**RESOLUTION OF THE CITY COUNCIL APPROVING THE PLANS AND SPECIFICATIONS AND AWARDING A CONTRACT TO GHILOTTI CONSTRUCTION COMPANY FOR THE VIKING LANE/MARKELEY LANE BYPASS PROJECT**

**VIKING LANE/MARKLEY LANE BYPASS**

Addendum No. 1

March 10, 2011

CITY OF FAIRFIELD			
DEPARTMENT OF PUBLIC WORKS			
SURVEY MONUMENT			
APPROVED	<i>Charles J. Smith</i>		
BY	CITY ENGINEER	R.C.E. 22878	
DATE JULY 1995	REV.	18.	
REV.	REV.

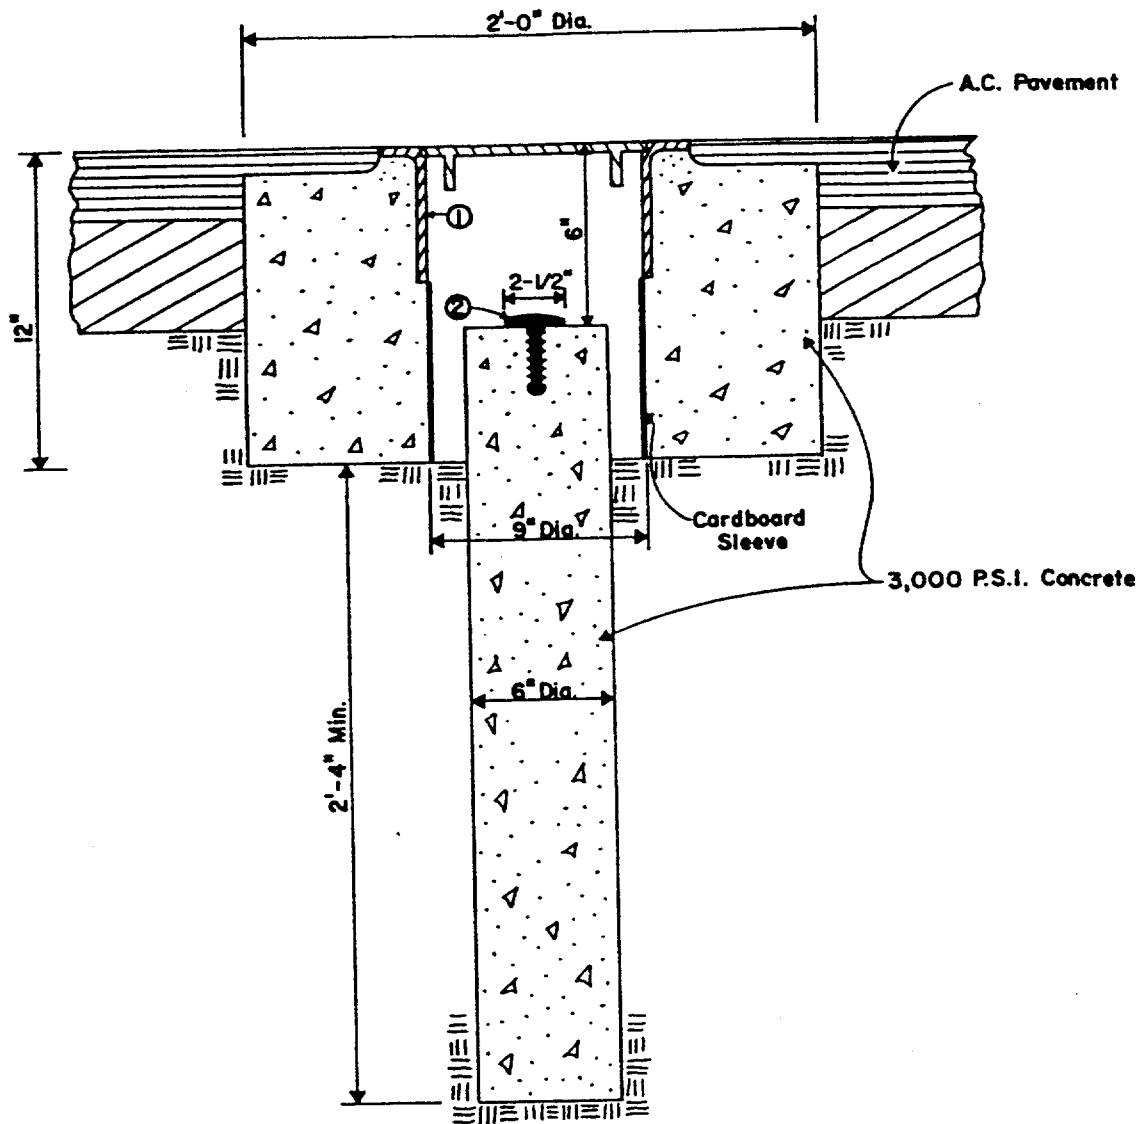
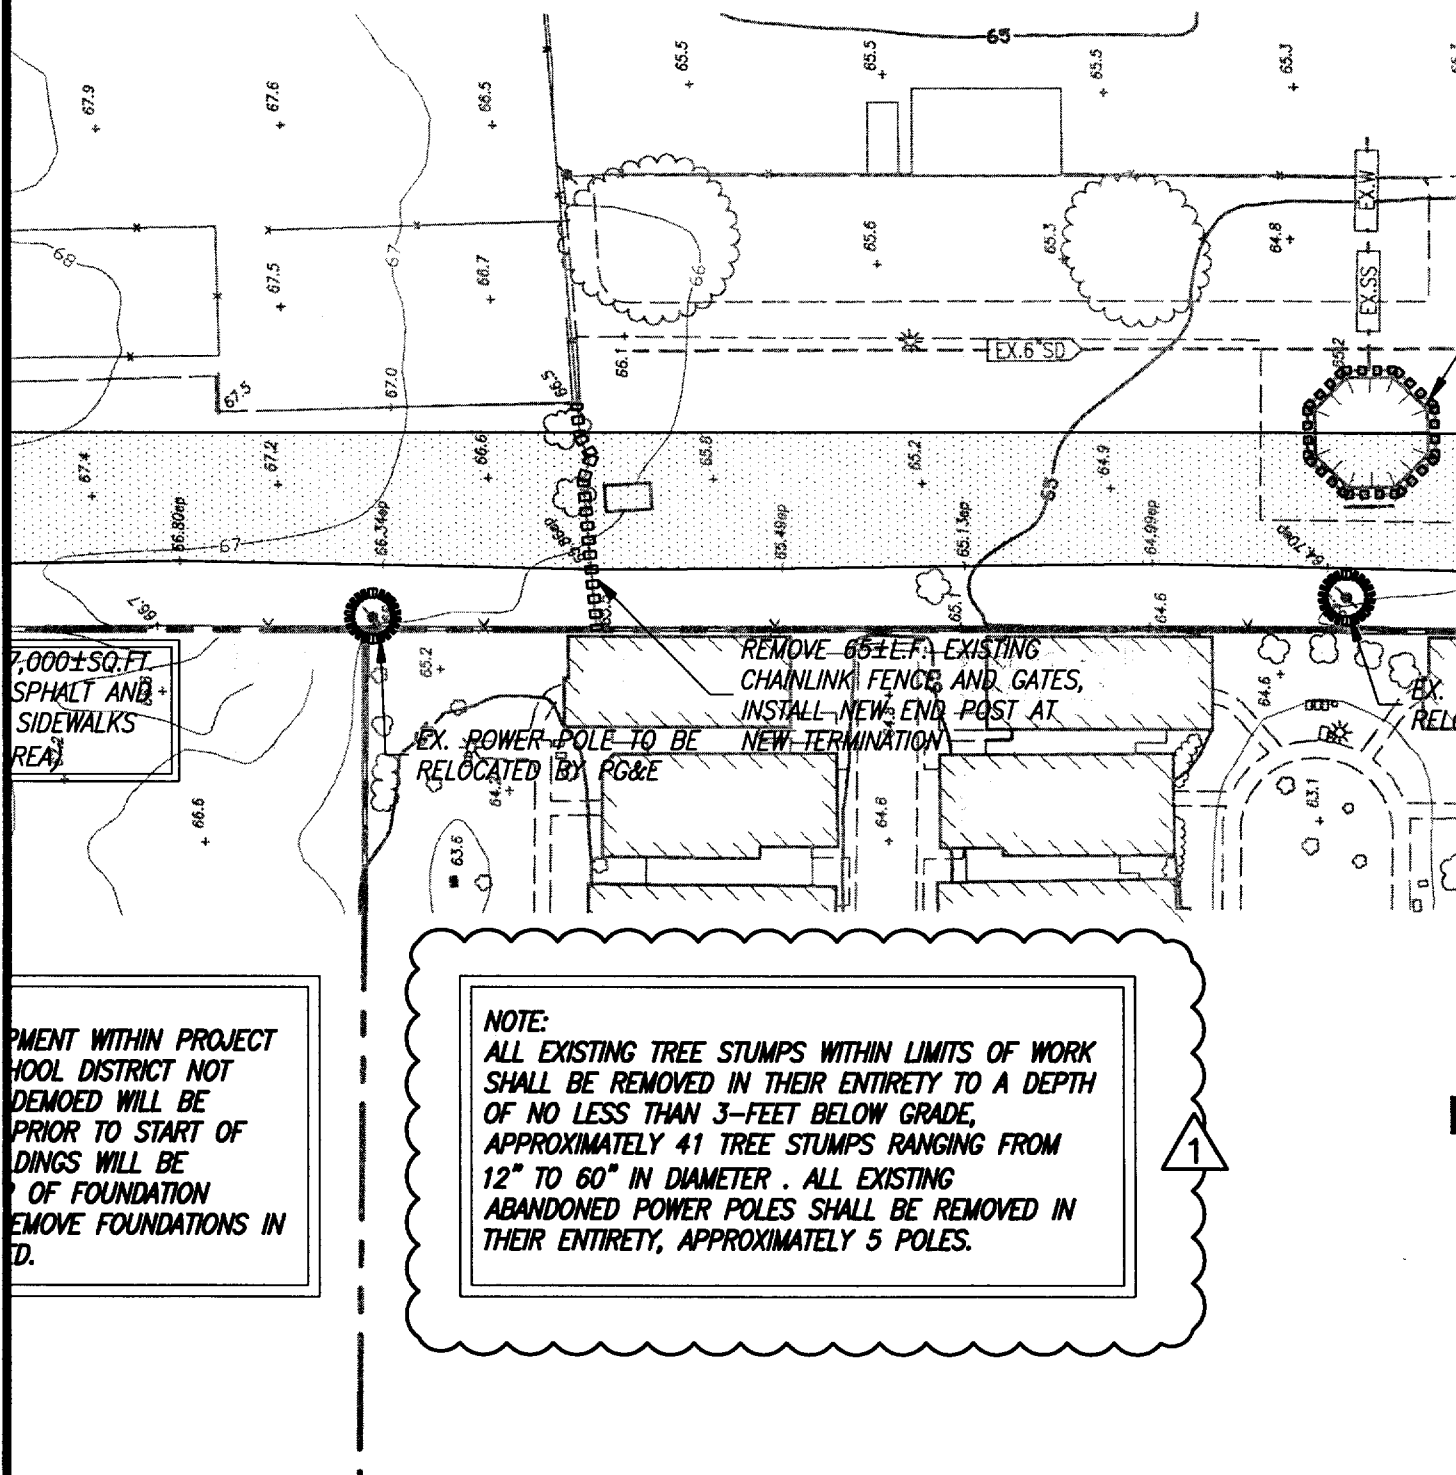
- A) Add City Standard Detail 18, Survey Monument.

1. MONUMENT FRAME & COVER SHALL BE CHRISTY CONCRETE G-5 VALVE BOX, TRAFFIC RATED, (10<sup>3</sup>/<sub>8</sub>" I.D.) OR APPROVED EQUAL.
2. SURVEY MARKER SHALL BE LIETZ 8134-16 OR SERVCO 2135.
3. THE R.E. OR L.S. NUMBER MUST APPEAR ON MONUMENT MARKER.
4. MARK REFERENCE POINT WITH A "+".
5. BOX LID SHALL BE LABELLED "MONUMENT."

**ADDENDUM #1**  
**SHEET C2**  
**CSK#1**

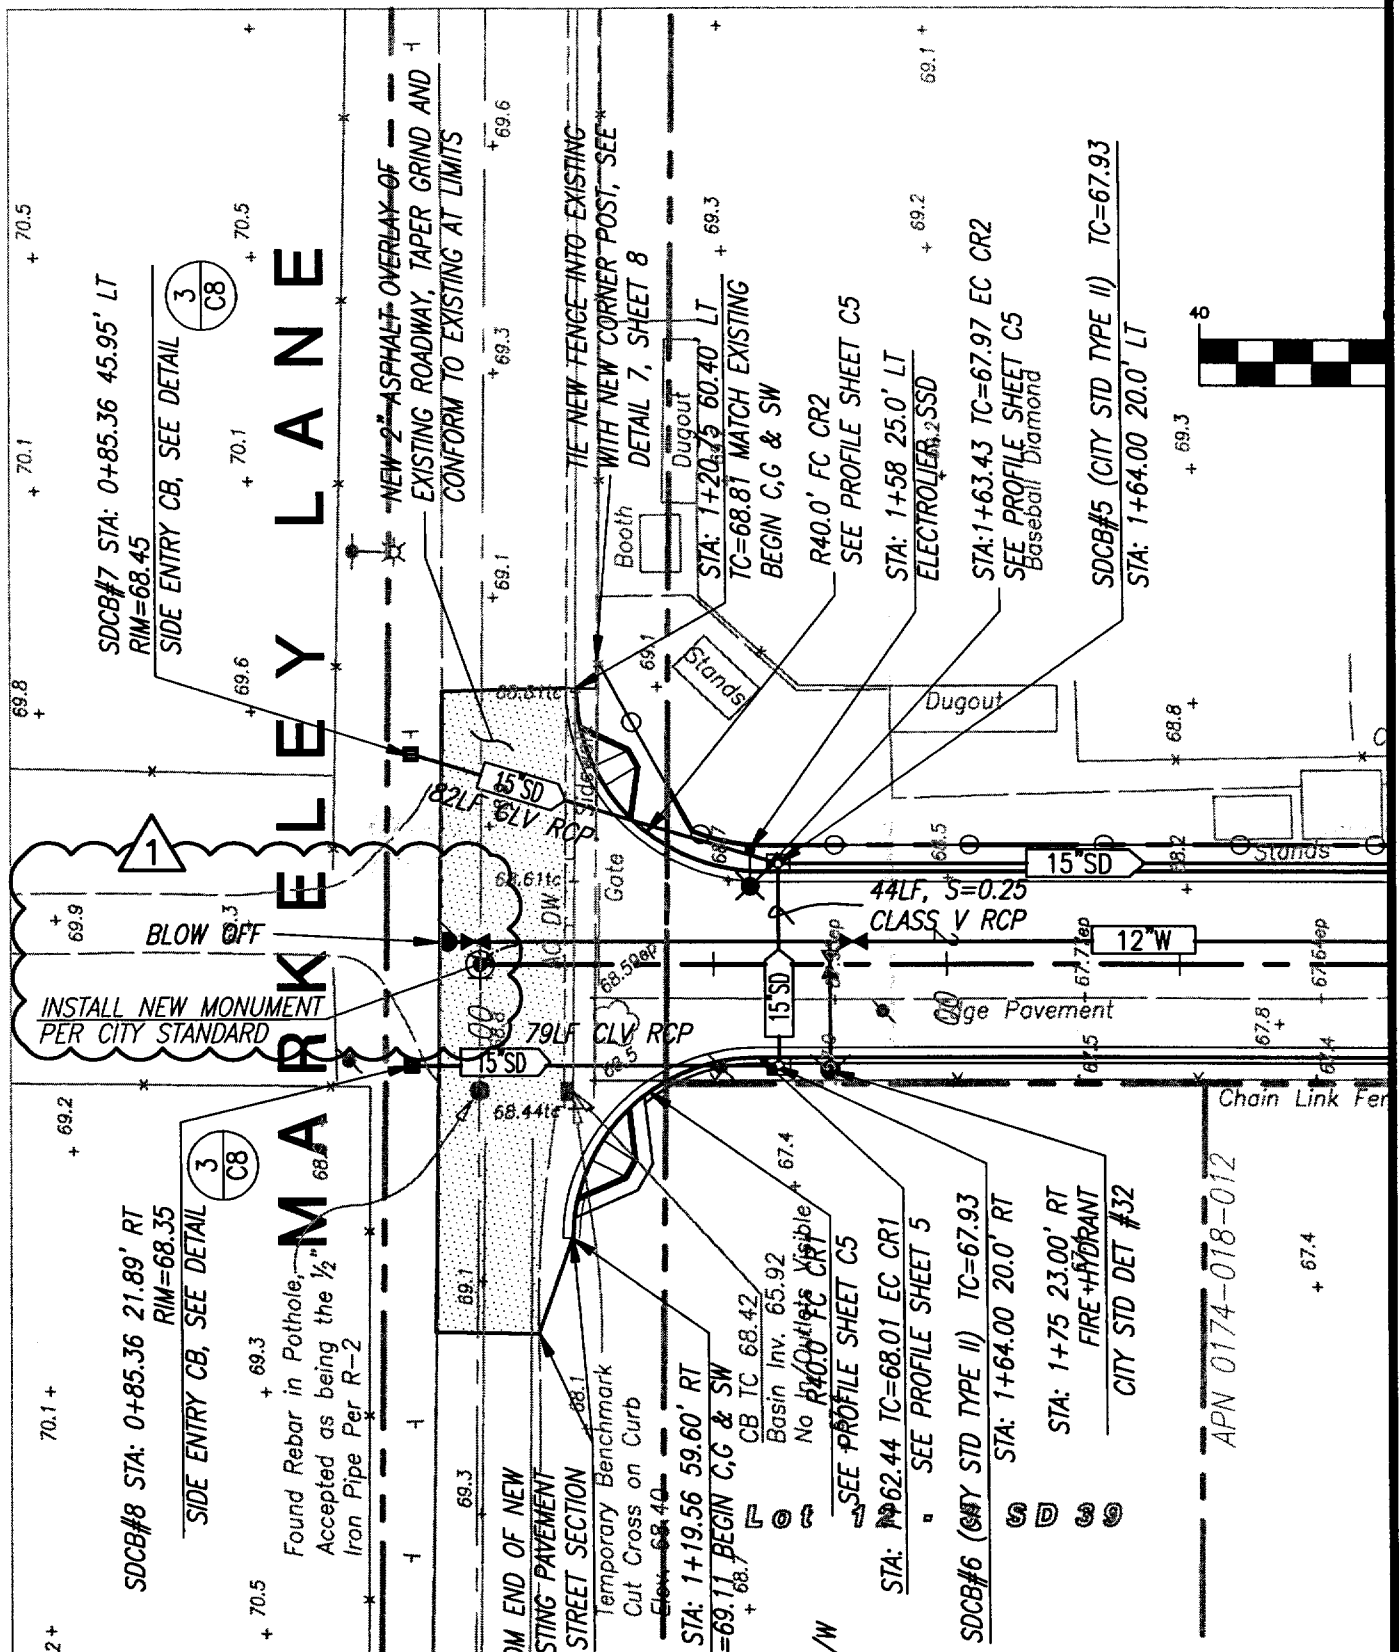
REMOVE 65±E.F. EXISTING  
CHAINLINK FENCE AND GATES,  
INSTALL NEW END POST AT  
NEW TERMINATION  
EX. POWER POLE TO BE  
RELOCATED BY PG&E

**NOTE:**  
ALL EXISTING TREE STUMPS WITHIN LIMITS OF WORK  
SHALL BE REMOVED IN THEIR ENTIRETY TO A DEPTH  
OF NO LESS THAN 3- FEET BELOW GRADE,  
APPROXIMATELY 41 TREE STUMPS RANGING FROM  
12" TO 60" IN DIAMETER . ALL EXISTING  
ABANDONED POWER POLES SHALL BE REMOVED IN  
THEIR ENTIRETY, APPROXIMATELY 5 POLES.

**24" SD AND JOINT TRENCH**  
**CROSSING**

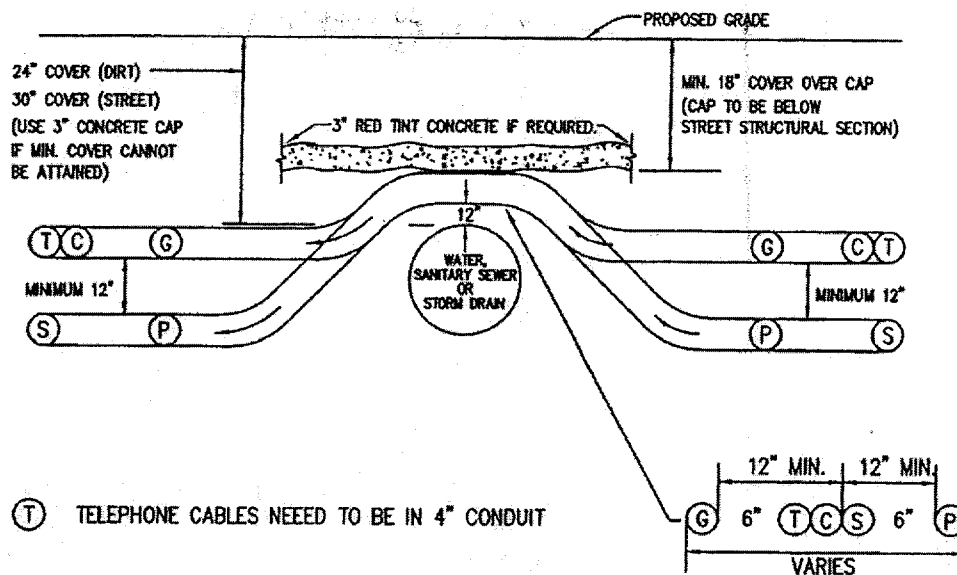
**JOINT TRENCH UNDER WATER, SANITARY SEWER OR STORM DRAIN**  
**OPTIONAL METHOD**

**JOINT TRENCH OVER WATER, SANITARY SEWER OR STORM DRAIN**  
**PREFERRED METHOD**

8' CHAINLINK FENCE

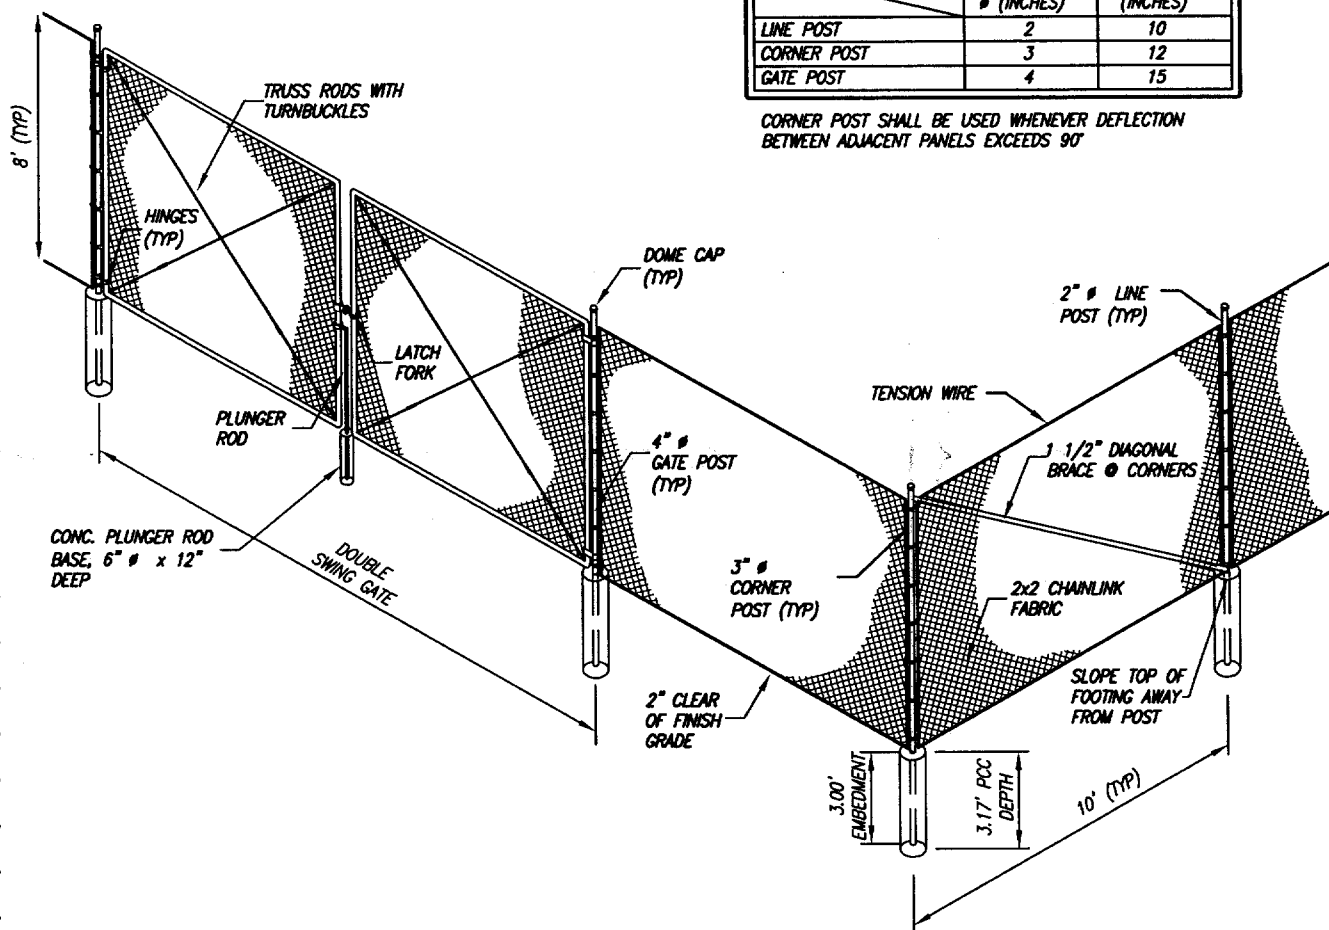
FENCE POST FOUNDATION		
	POST INSIDE # (INCHES)	FOOTING # (INCHES)
LINE POST	2	10
CORNER POST	3	12
GATE POST	4	15

CORNER POST SHALL BE USED WHENEVER DEFLECTION BETWEEN ADJACENT PANELS EXCEEDS 90°
